Illinois Department of Transportation

SUBJECT: FAI Route 90/94/290 (I-90/94/290)
Project NHPP-VQI4(255)
Section 2014-013R&B-R
Cook County
Contract No. 60X93
Item No. 4, November 9, 2018 Letting
Addendum B

NOTICE TO PROSPECTIVE BIDDERS:

Figure No. 1

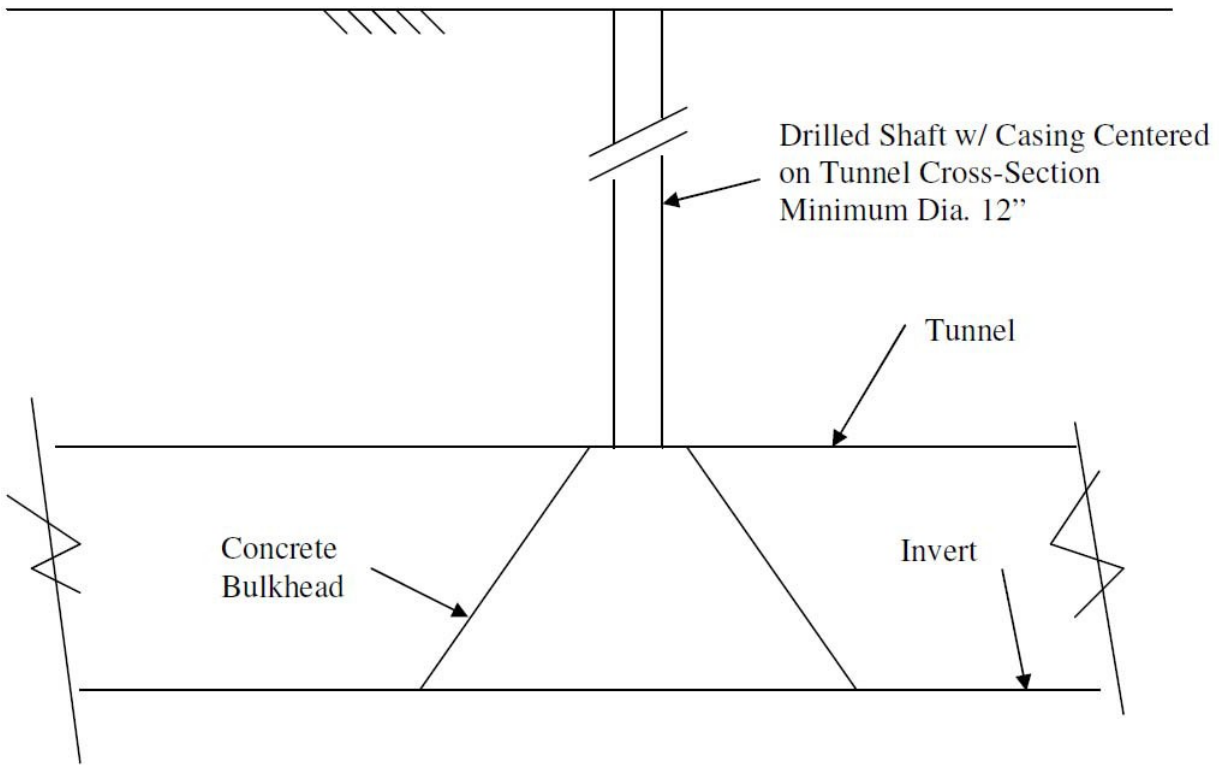
Construction Requirements. Procedure for Establishing Bulkheads within the Existing Water Tunnel:

1. Calculate the amount of very low slump, lean concrete needed to form bulkhead in tunnel.
2. Determine if water is contained in tunnel.
3. Place concrete in tunnel to 1 ft above top of tunnel (use tremie methods if tunnel contains water). Actual amount of concrete placed must be compared to calculated amount to fill tunnel.

4. When concrete sets, drill a 4" core to the invert of tunnel. Verify from an examination of the cores that the bulkhead has no discontinuities.
5. If the bulkhead verification is satisfactory by the Engineer, complete filling the core hole with concrete to surface.

6. Keep core samples drilled for verification for inspection for a minimum of 4 weeks.
7. If the bulkhead cannot be confirmed, move to new location (6 to 8 ft away) and keep repeating procedure until tunnel bulkhead closure can be confirmed.
